# CITY OF SACRAMENTO

- SUBJECT:
1. Environmental Determination
  2. Subdivision Modification to create two lots less than 100 feet in depth
  3. Subdivision Modification to allow a street jog of less than 120 feet
  4. Tentative Map (P83-412) (APN: 038-111-021)

LOCATION: South side of Lemon Hill Avenue, approximately 725 feet east of 65th Street

TENTATIVE MAP  
FOR  
**EL RANCHO ESTATES**

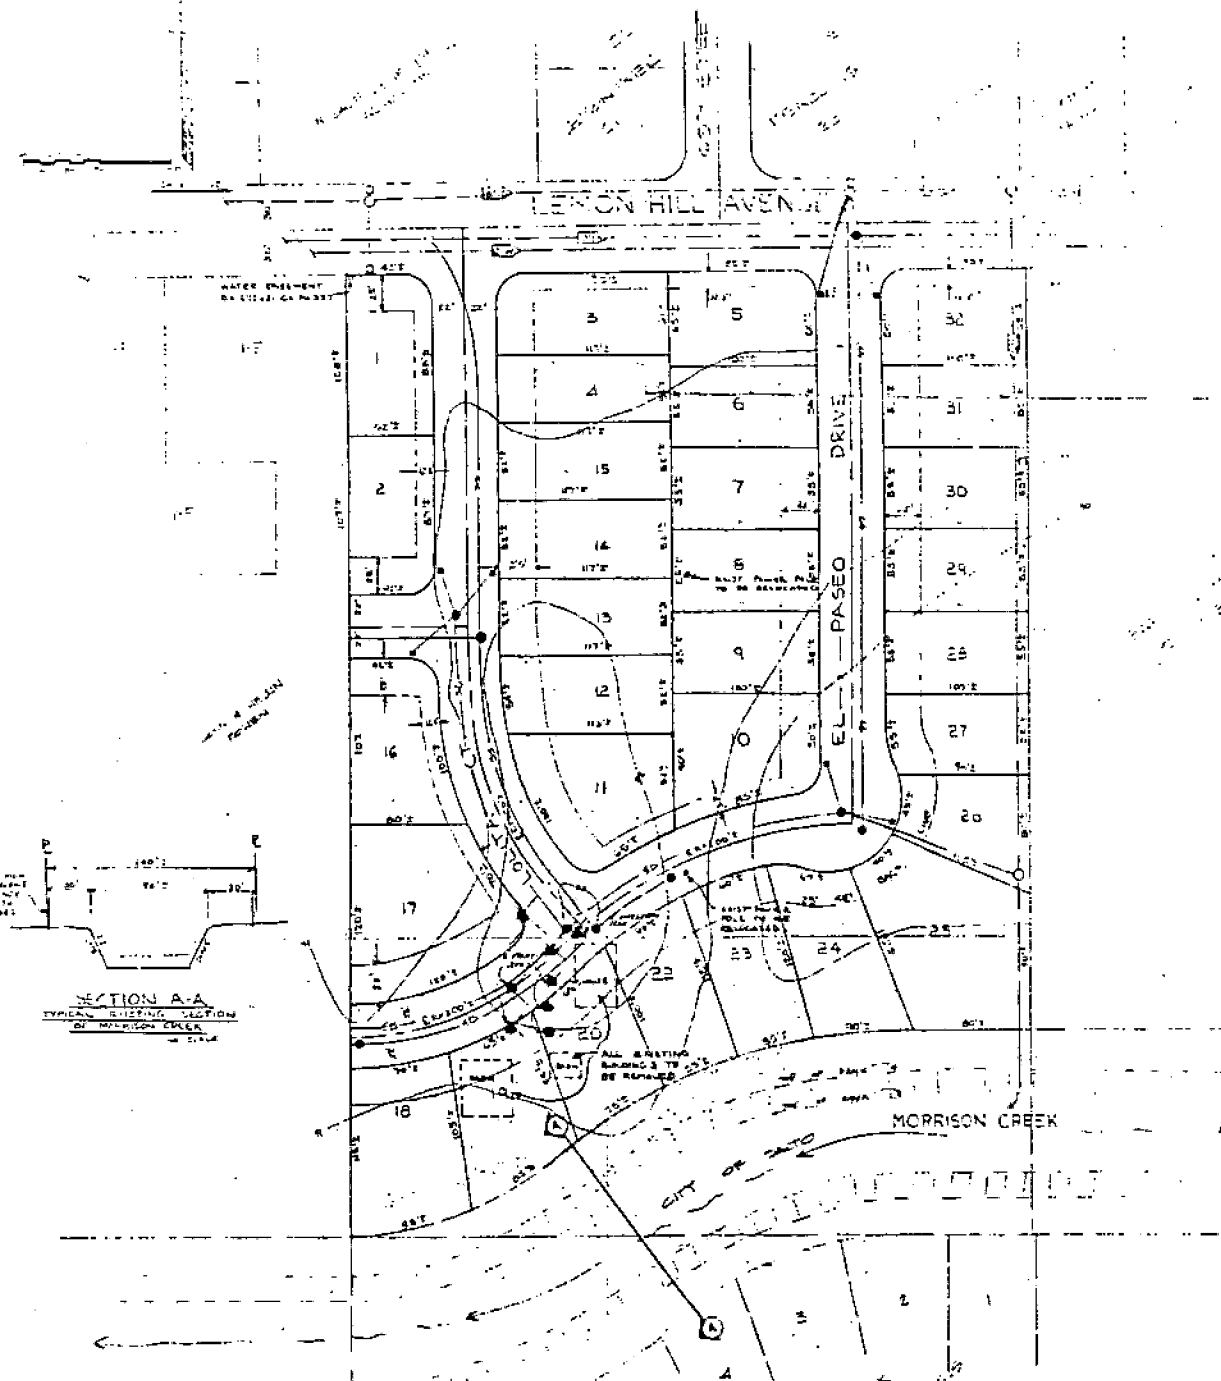
The applicant is requesting a Subdivision Modification to create two lots (Lots 26 and 27) that are less than 100 feet in depth and to allow a street jog of less than 120 feet from the center lines of 69th Street and proposed El Paso Drive. The modifications are justified because of the size and width of the lot in relationship to 69th Street. Staff has no objection to the requests.

1. Staff has no objection to creating two lots (lots 26 and 27) with a depth less than 100 feet. The lot sizes do not fall below the minimum 5,200 square feet.

2. The applicant's proposal consists of a street design that will create a street jog of less than 120 feet, as illustrated by Exhibit A. The Subdivision Ordinance requires that street centerlines (street jogs) be offset by a minimum of 120 feet and the applicant is proposing a jog of 75 feet. The substandard jog is a result of the approved street location for 69th Street on the north side of Lemon Hill Avenue. Also, the size and configuration of the subject site makes it difficult to accommodate the minimum 120 foot street jog.

6. In the matter of the hereby approved requested subdivision modification to allow two lots that are less than 100 ft. in depth and to allow a street jog of less than 120 ft.

that it is impossible, impracticable and undesirable in this particular case to conform to the strict application of City Code Chapter 40 in that the width and size of the site in relationship to 69th St. make it difficult to meet this standard requirement.

EXHIBIT A

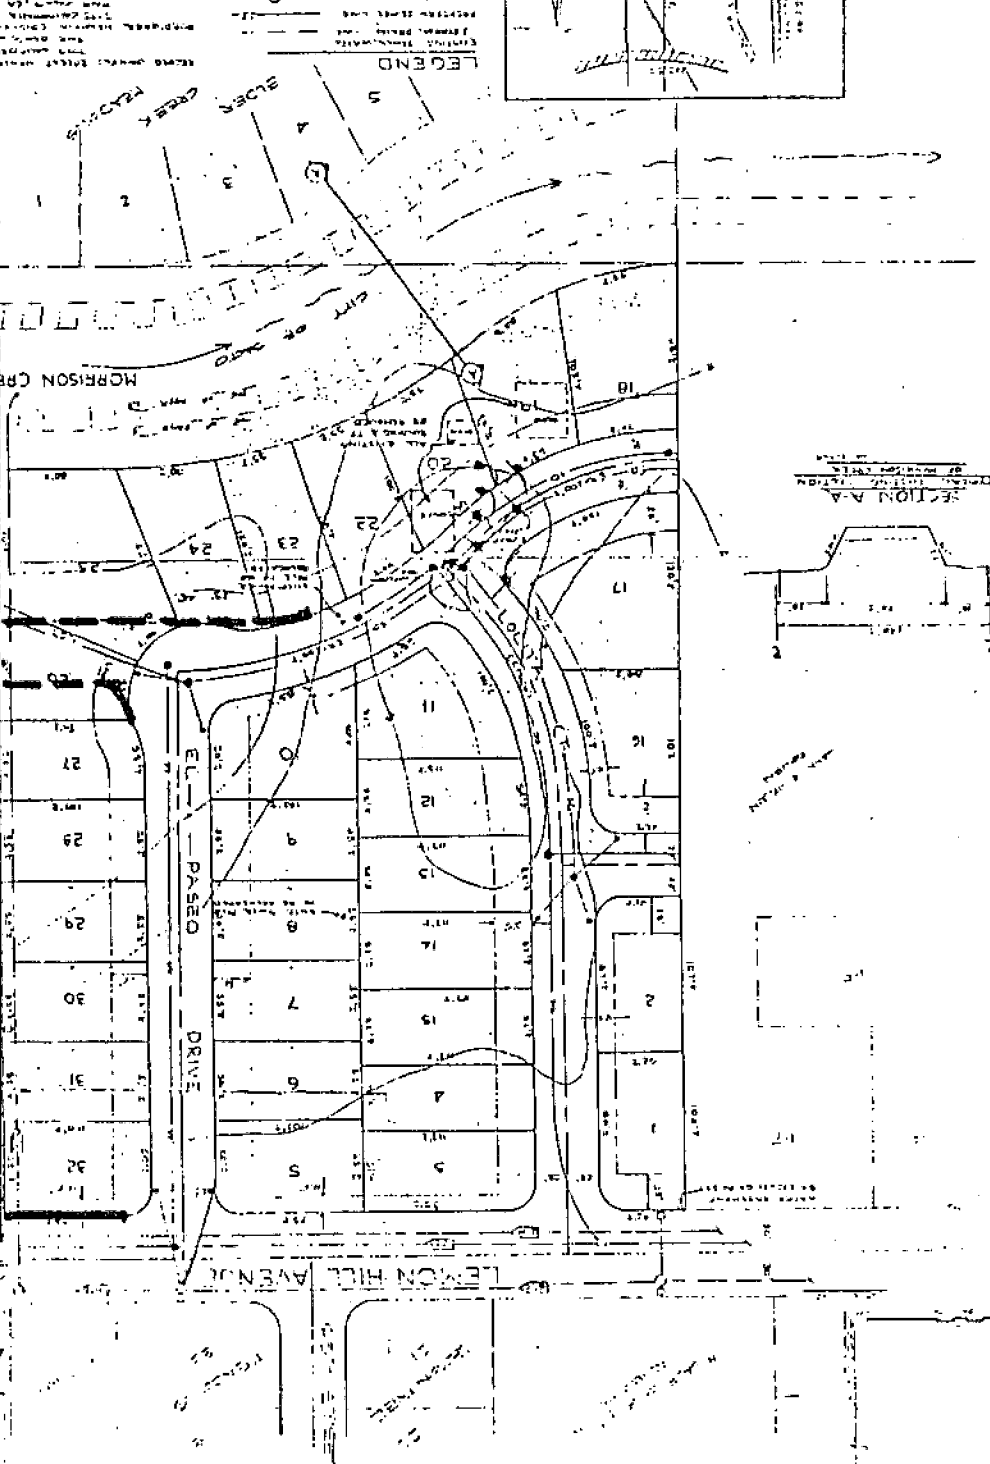
- a. 'T' Design: This design as indicated on Exhibit A would require the applicant to design a stub street to provide access to the rear of Lot 12. This would create 16 new lots to the rear of Lot 12. This will also require removal of the large detached accessory structure in order to extend a future public street from Lemon Hill Avenue.

In reviewing the four alternative designs, it has been illustrated that Lot 12 can be designed without providing a stub street from the applicant's property. Lot 12 can therefore be subdivided on its own or with adjacent properties to the east. Staff therefore has no objection to the applicant's original subdivision design.

# TENTATIVE MAP EL RANCHO EST. EXHIBIT "B"

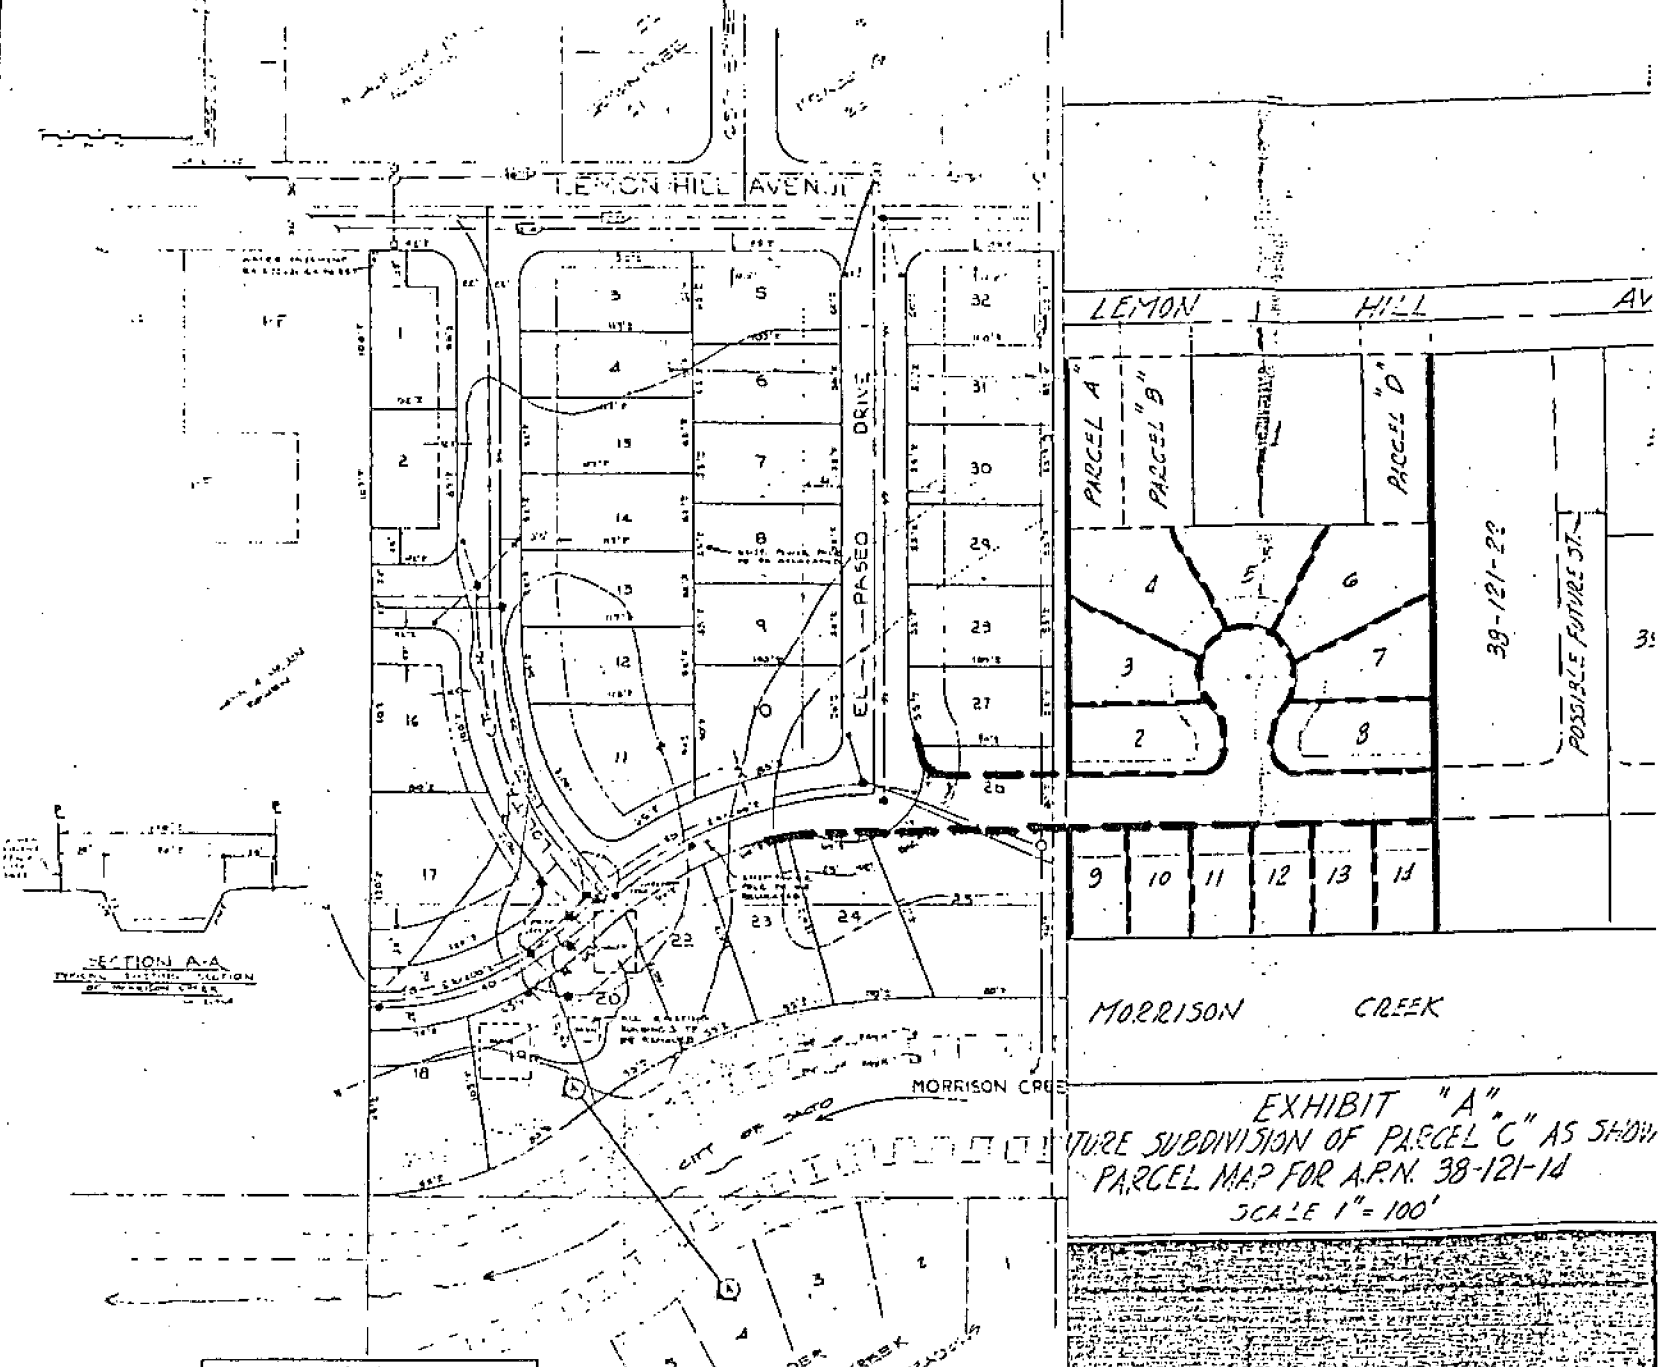
- b. Cul-de-sac and 'T' Design: This design, as indicated on Exhibit 'B', would require the applicant to design a stub street to provide access to the rear of Lot 12. This design would also create a cul-de-sac and a total of 13 lots on the rear portion of Lot 12.
